Planning Commission Regular Meeting

Monday, January 26, 2026, 6:30 PM
106 Center Street

ADDITION & REMODELING FOR:
BENNETT RESIDENCE
150 BELL STREET
EXCELSIOR, MN

① Front Elevation
1/4" = 1'-0"

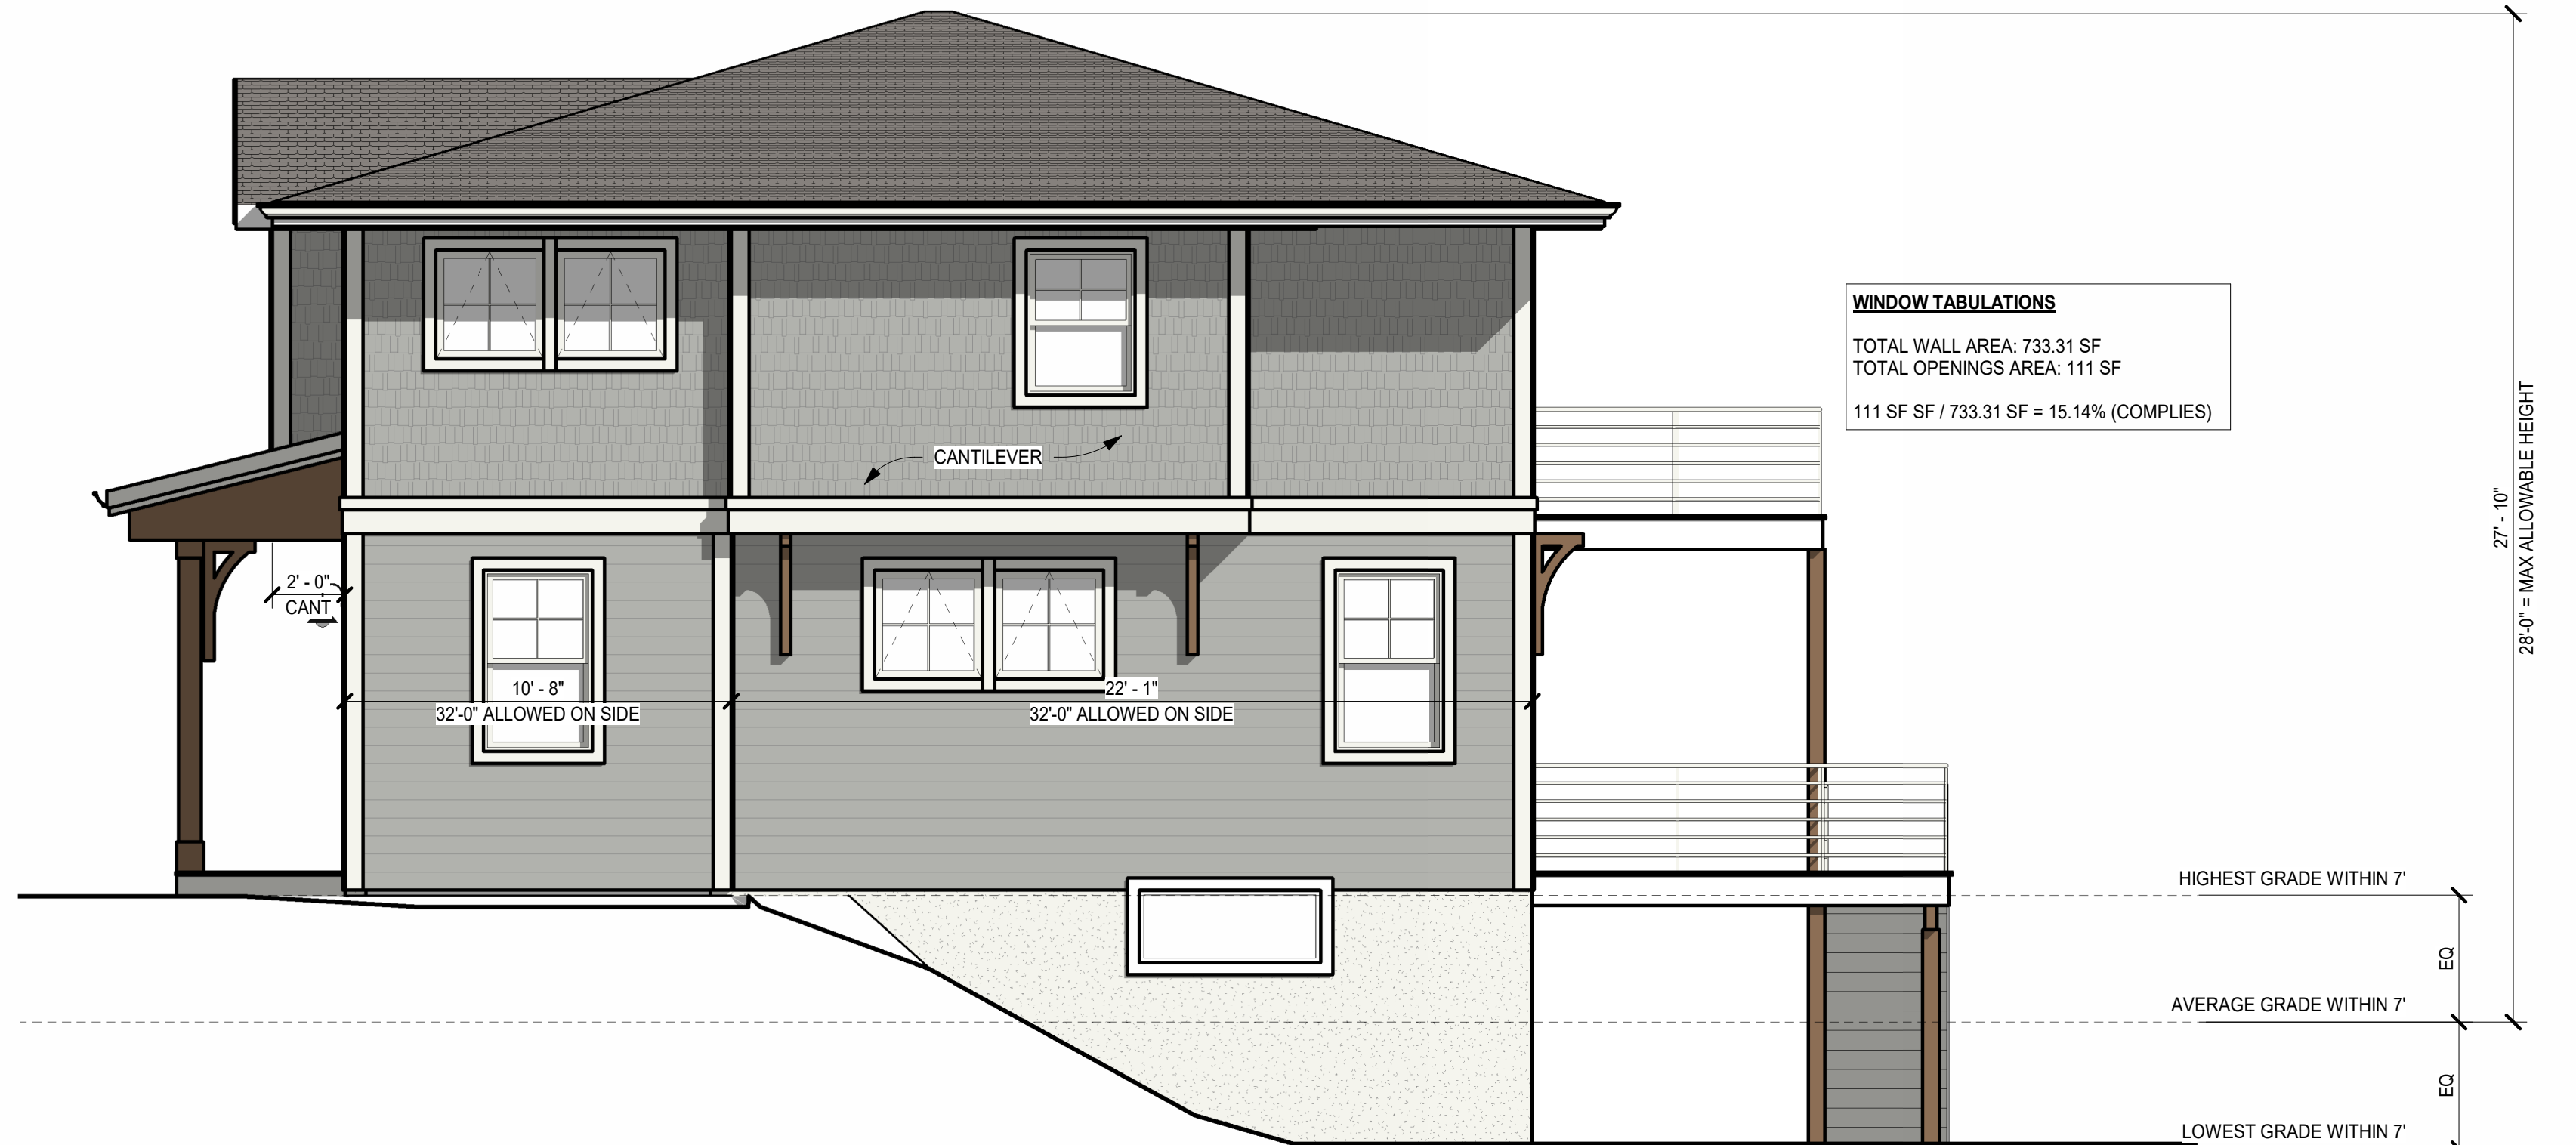
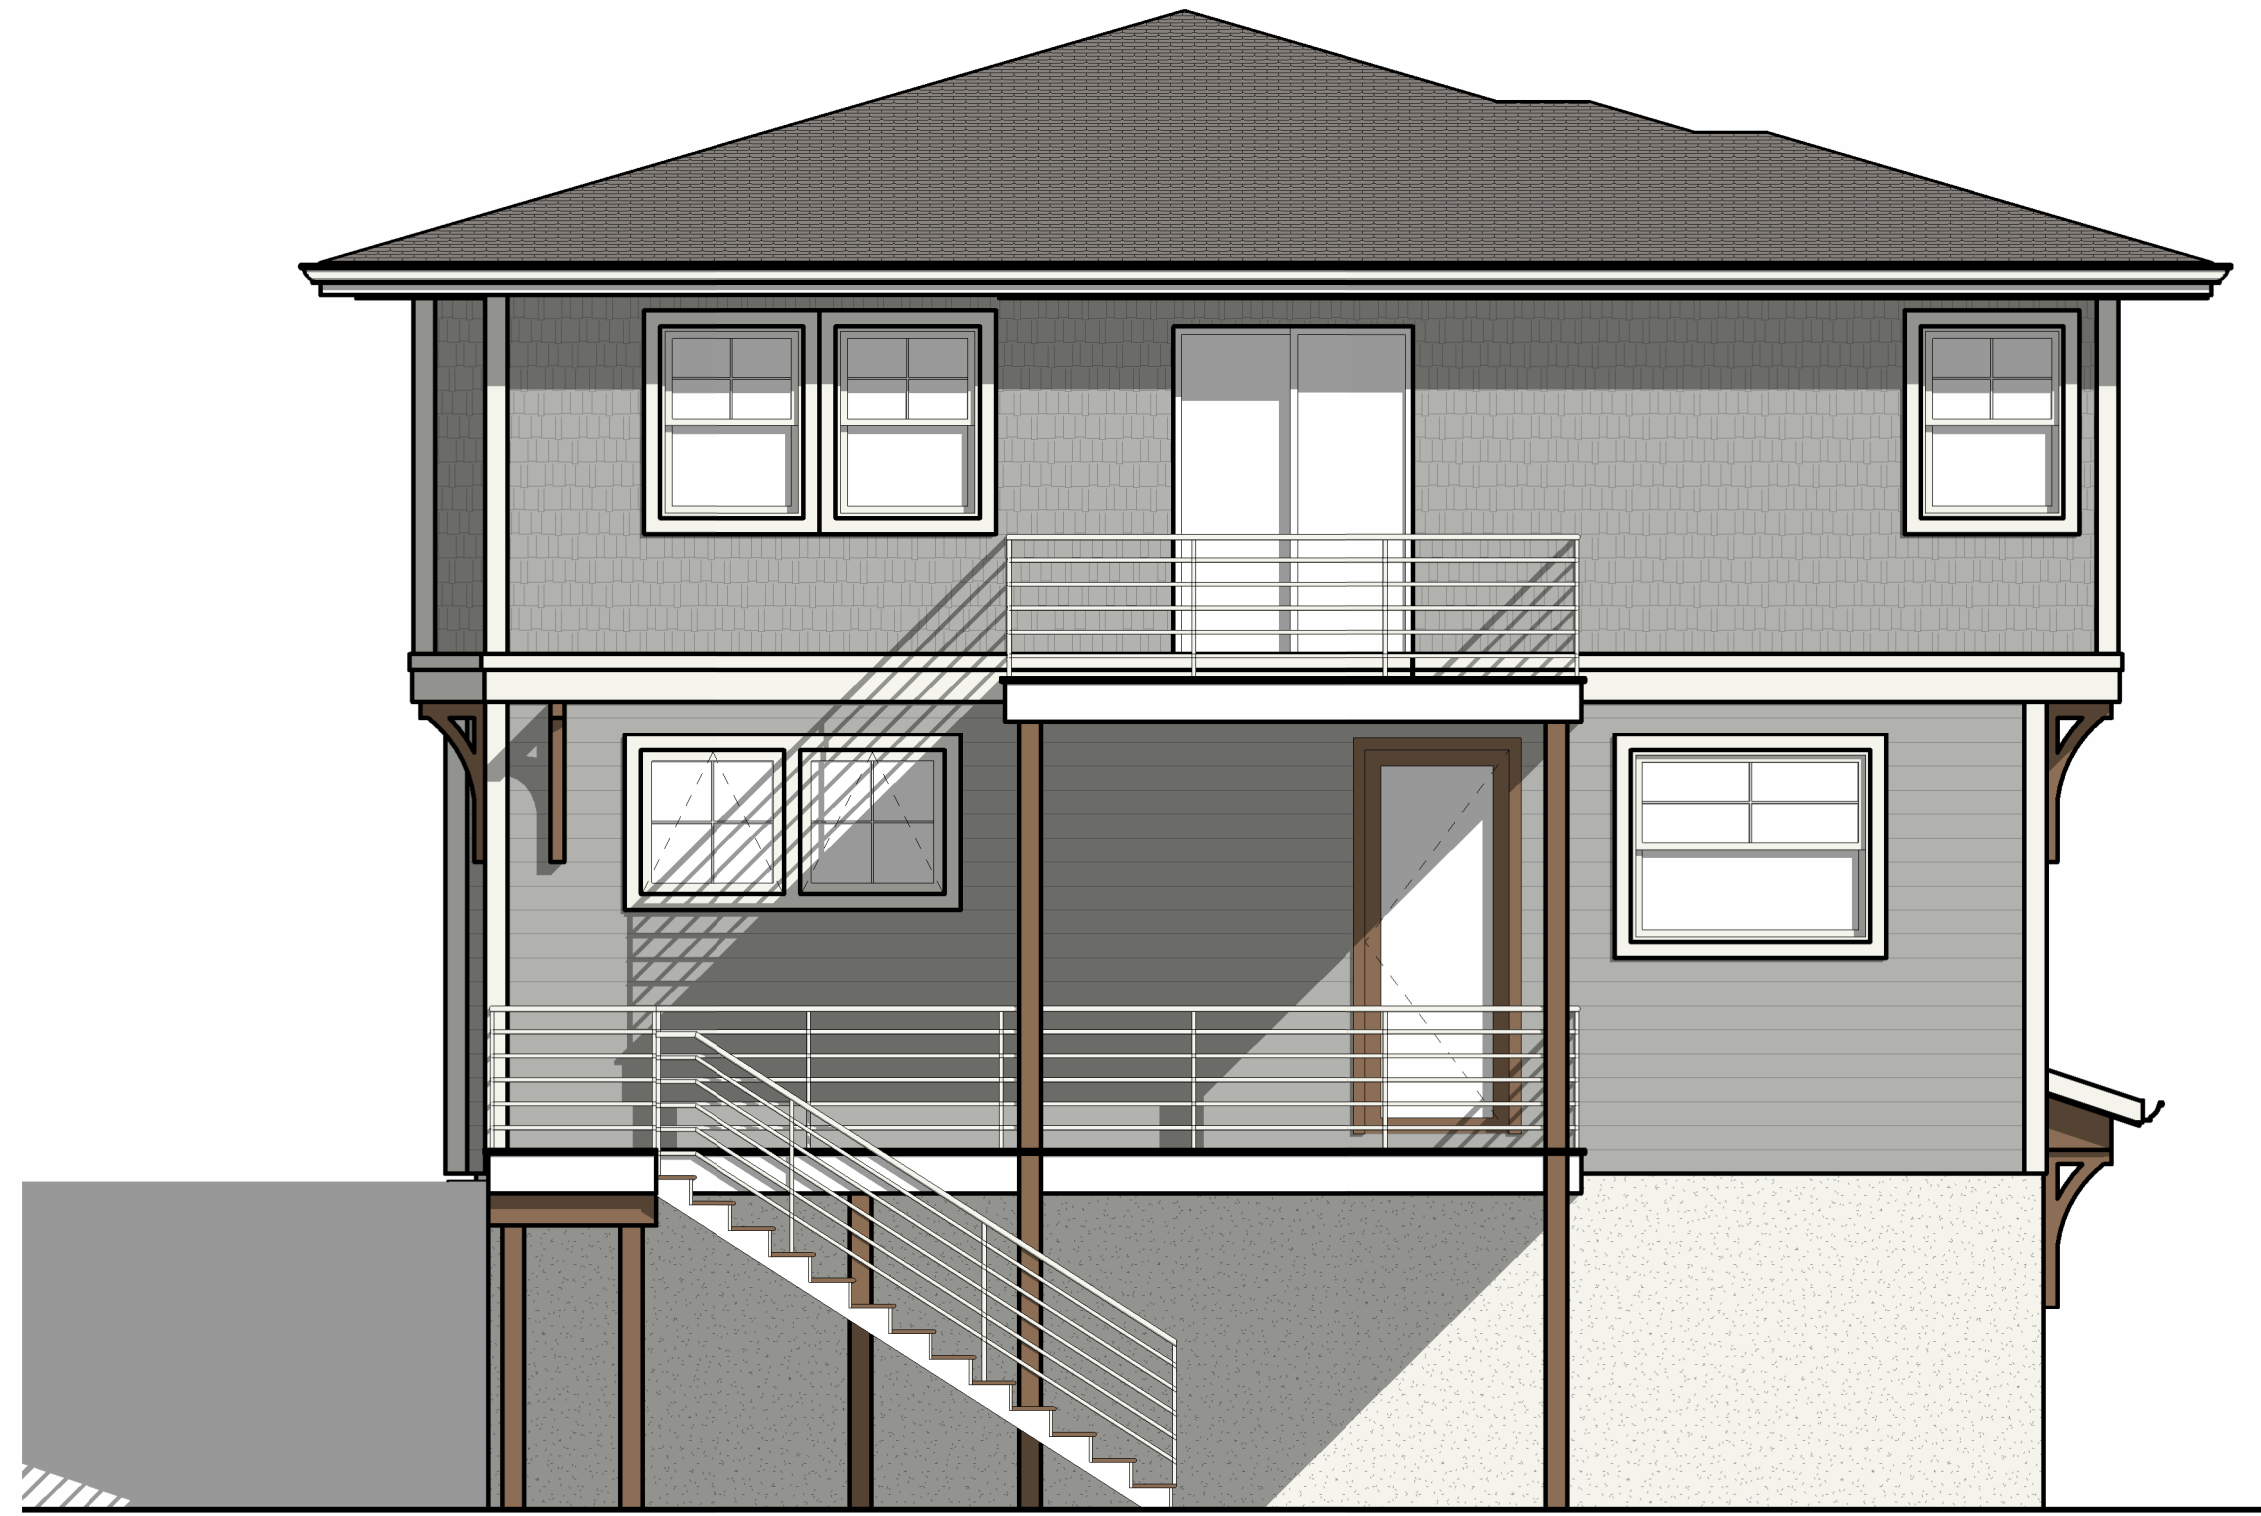
from the lowest elevation within the 7' area around the structure. The proposed home also requires a variance from wall plane requirements. The proposed home includes cantilevers within the design, however, these cantilevers do not meet the minimum size requirements for offsets on wall planes. Sec. 41-10 requires that exterior side and rear walls shall not exceed 32 feet without a minimum of at least a two-foot deep by eight-foot-wide offset (projecting or recessed) within every 32 feet or less.

The applicant submitted architectural elevations which shows the home has been designed to be viewed from multiple angles. It is well detailed on all four sides. The use of windows and decorative brackets provide design details to the home. Increasing the projection of the proposed cantilever on the right side of the building would prevent the need for a side wall plane variance.
